**PLANNING & ZONING COMMISSION
Special Meeting
Wednesday, February 1, 2017
6:30 p.m.**

TO: Planning & Zoning Commission
FROM: Heather Valone, Village Planner
THRU: Jeffery Stein, Deputy Village Administrator
SUBJECT: Case 14-12 Donegal Excavating PUD
DATE: January 4, 2017

Case No. 14-12
Project Name Donegal Excavating

Re: Donegal Excavating
Case #2014-12
Plan Review #1

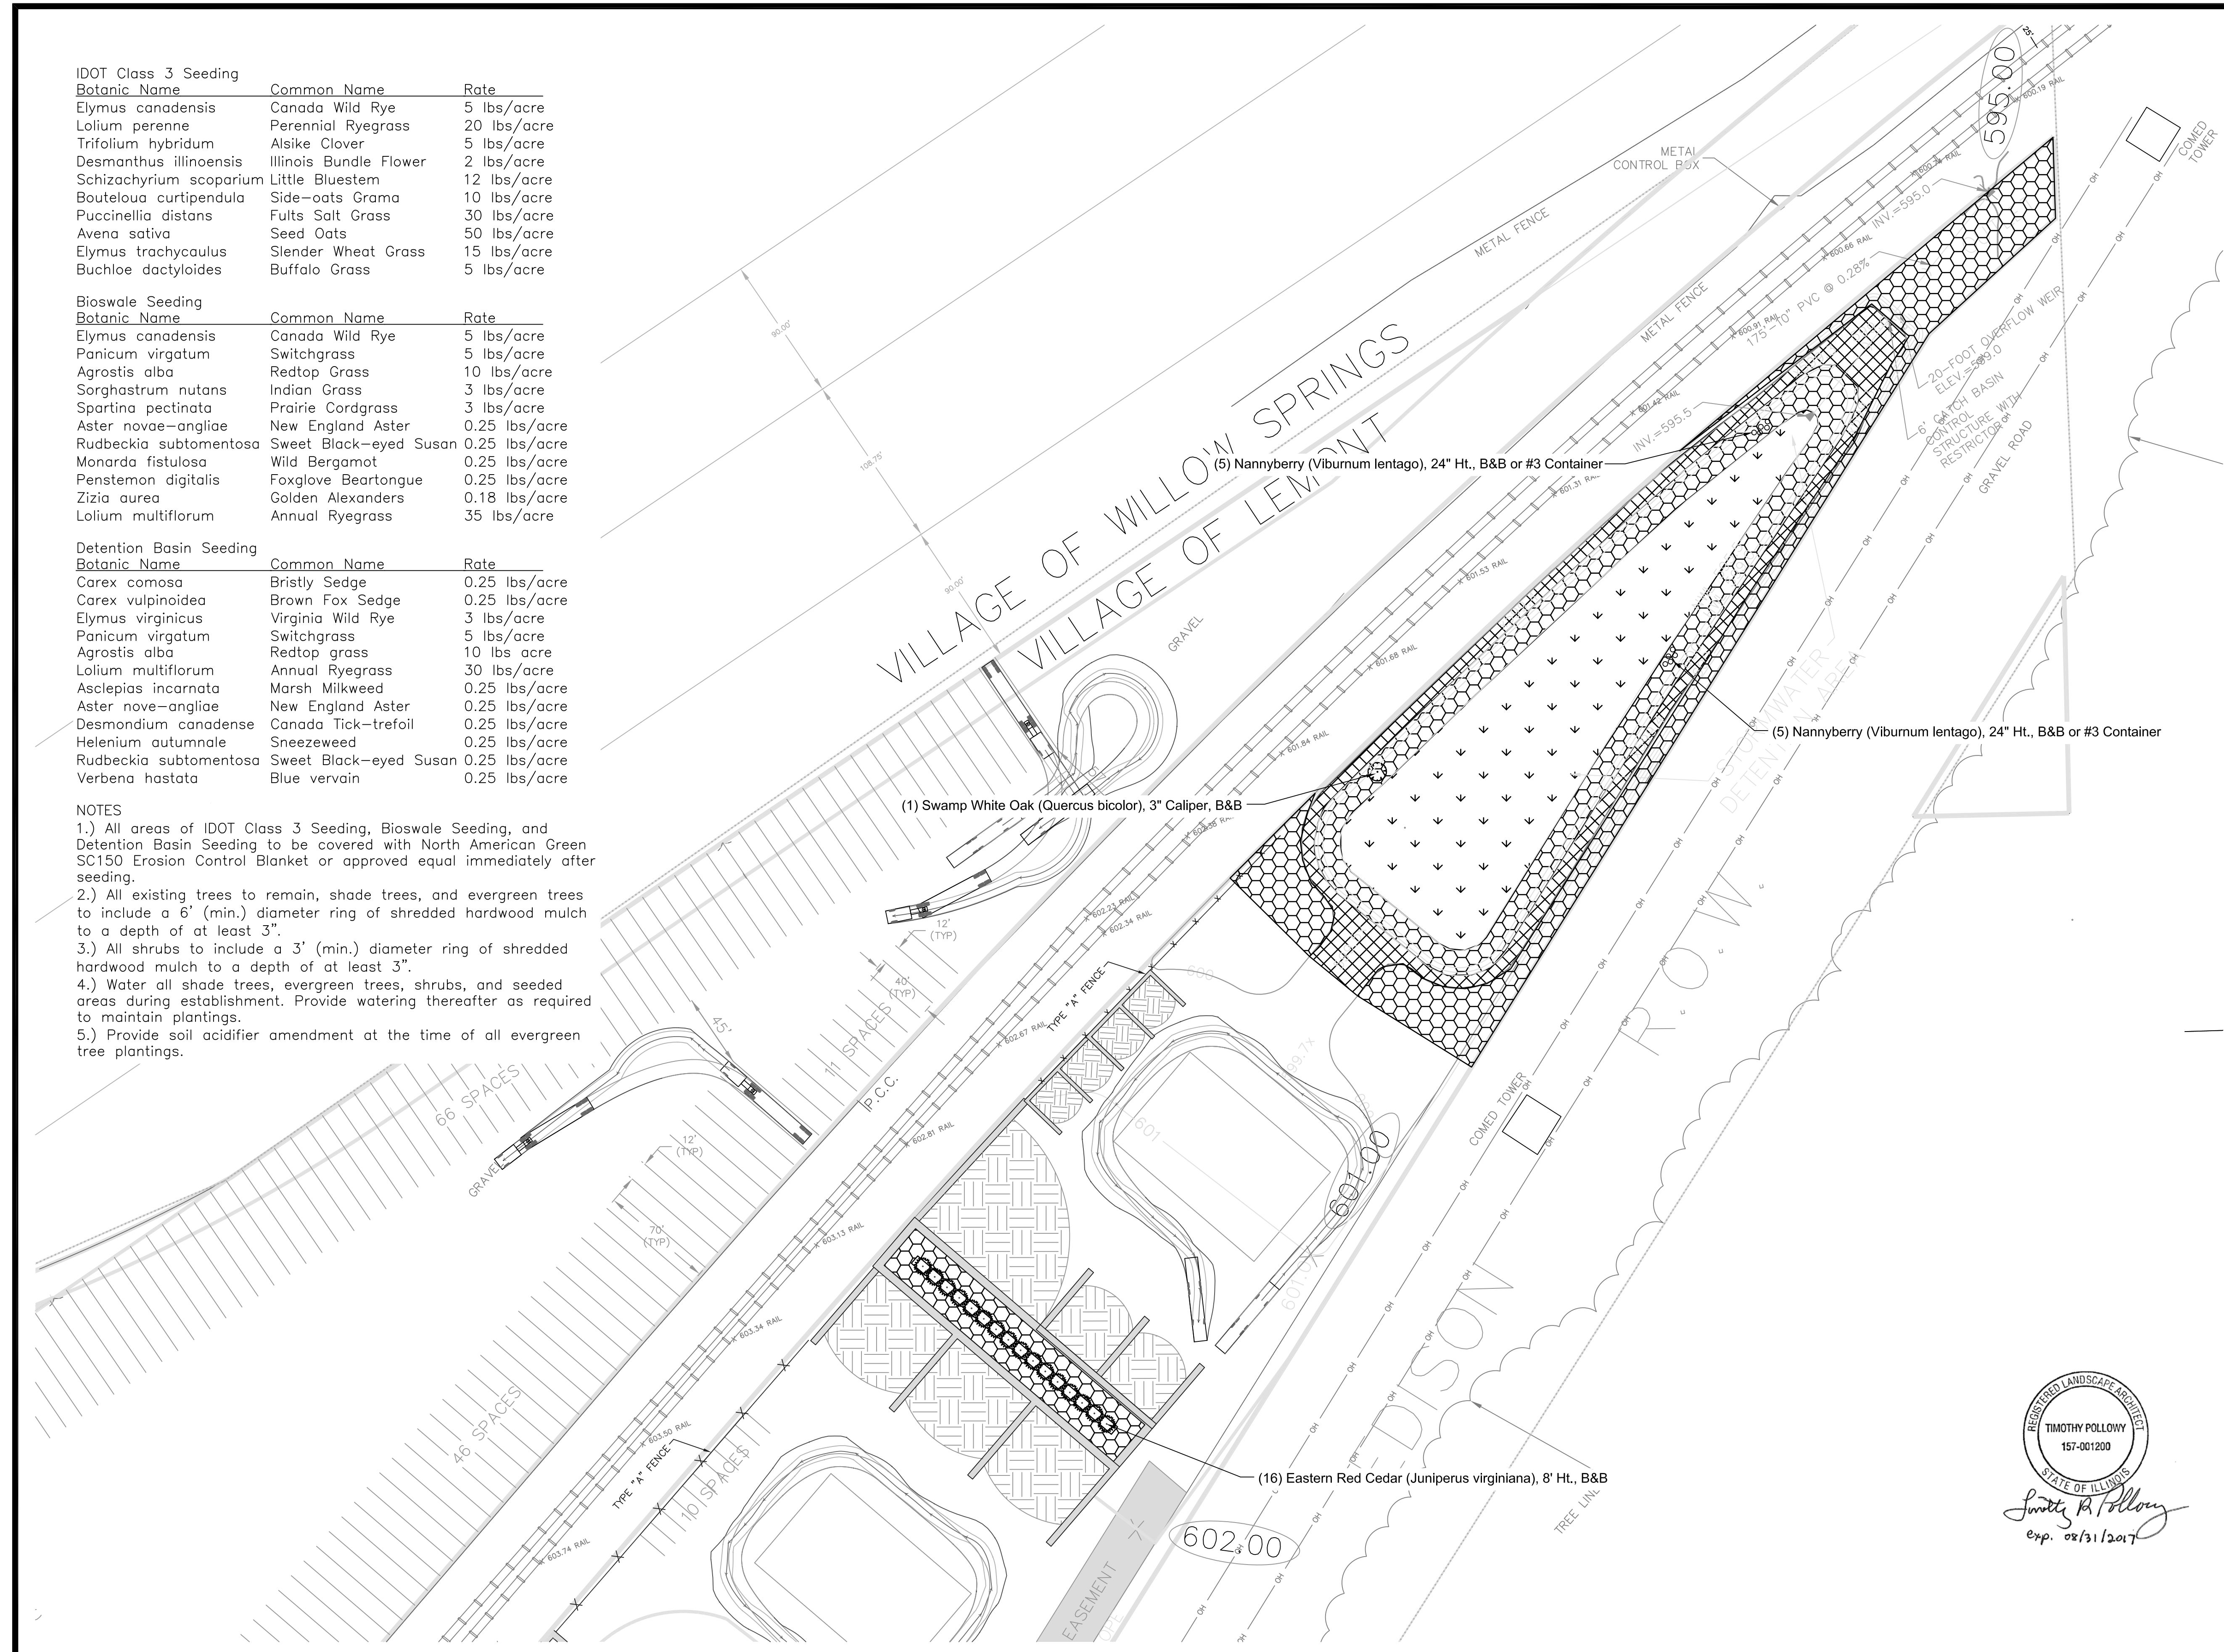
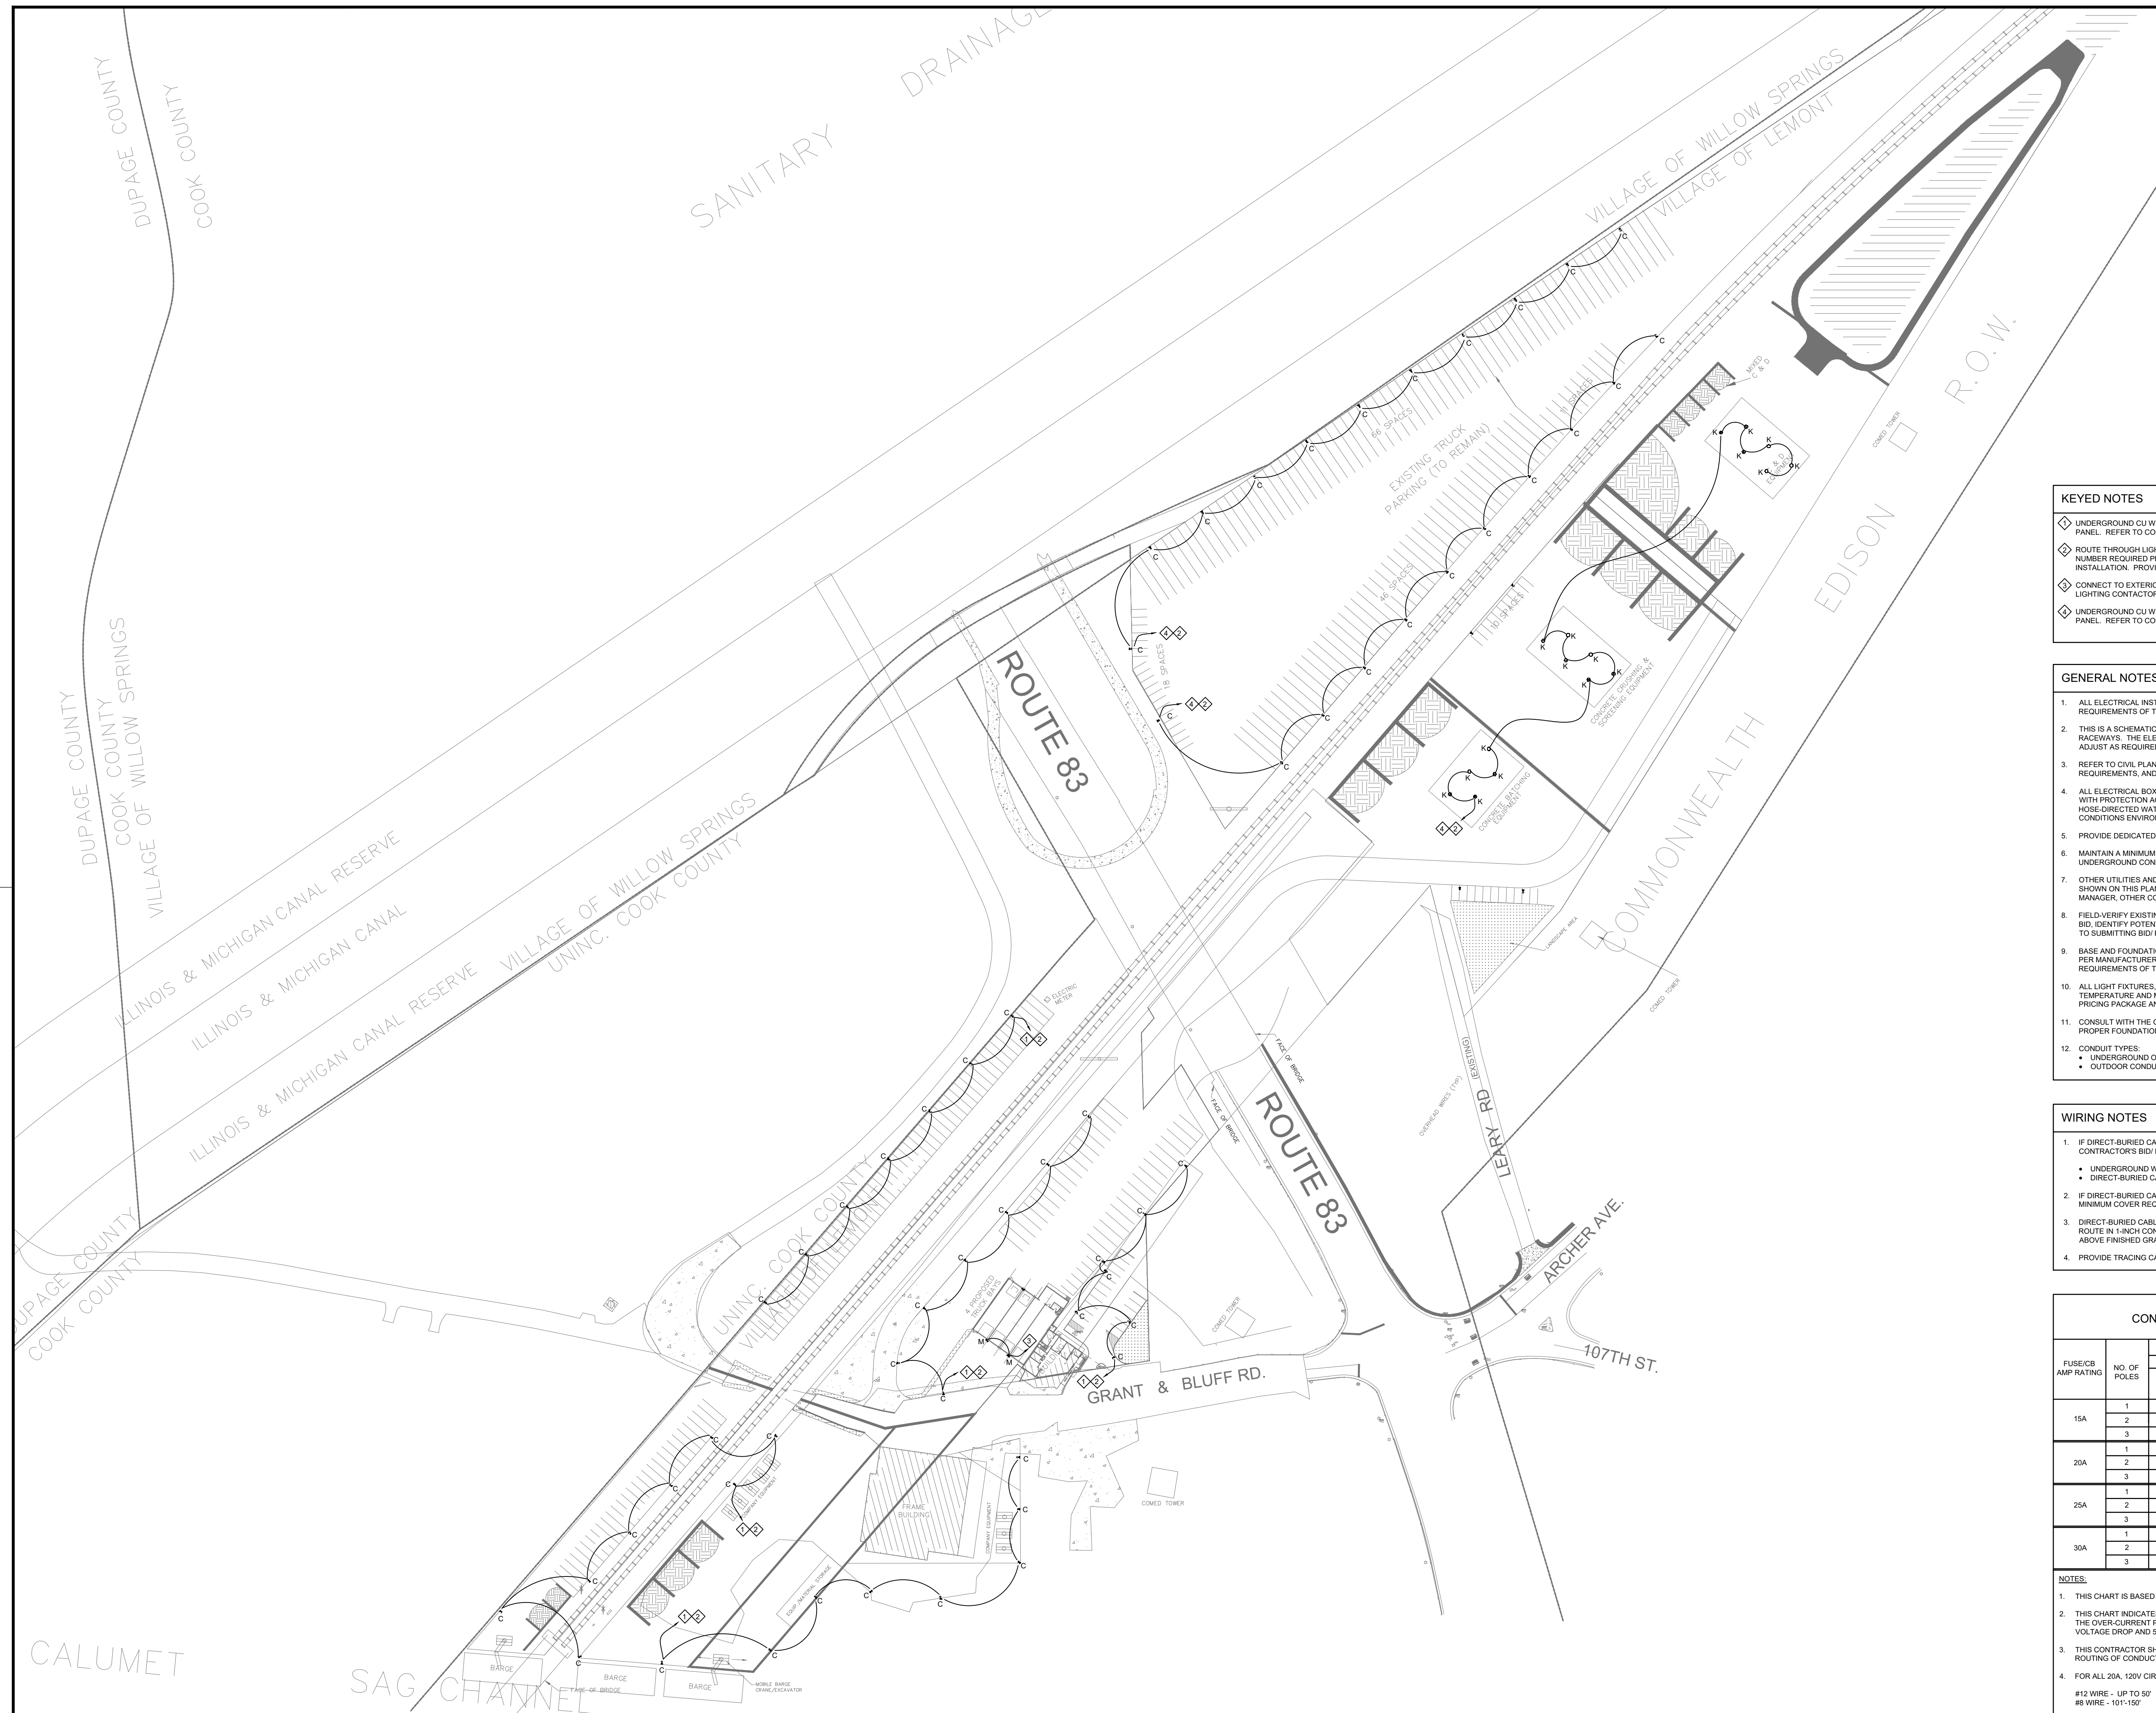
The landscaping plan and the engineering plans depict different amounts of landscaping along the private road through the box culvert. These plans must be revised to be consistent with one another and not contradictory to each other.

The Village Arborist reviewed the application and noted that the proposed plants are suitable for the industrial sight. There are deficiencies in the employees' parking lot landscaping which should be revised. The Village Arborist had no concerns with the use of fencing along the railroad tracks being used in lieu of landscaping along the parcels north of the tracks. Information on the existing trees is missing and requested by the Village Arborist to be included on the landscape plans.

1. The landscape plan notes indicate that all existing trees will be retained. There are three tree symbols on the existing conditions plan, but there was no information as to the species size and condition of the trees. The landscape plan shows one 36" D.B.H. tree to remain. The species and condition of the tree were not provided.

2. The landscaping opportunities for this site are limited. The landscape plan is generally suitable to the site. The proposed landscaping for the storm water detention area is not consistent with landscape standards in Section 17.20.080 of the Village Ordinance.

3. The use of fencing along the north side of the railroad ROW instead of landscaping for the truck and equipment parking is acceptable. The landscaping in the normal employee parking lots must be revised to increase the landscaping and landscaped islands.

3. Revise the landscaping plan to include at least one (1) plant unit per 100 ft. of frontage along Grant Rd. and Leary Rd.
4. The landscape plans must also be updated to increase the landscaping around the exterior of the employee parking area.

5. Incorporate 595 sf. of landscaped islands between the employee parking area and the truck/equipment parking area on Lot 2.
6. Update the engineering plans and the landscape plans to show the same landscaping and fencing information and show a fence along the railroad ROW on Lot 6.
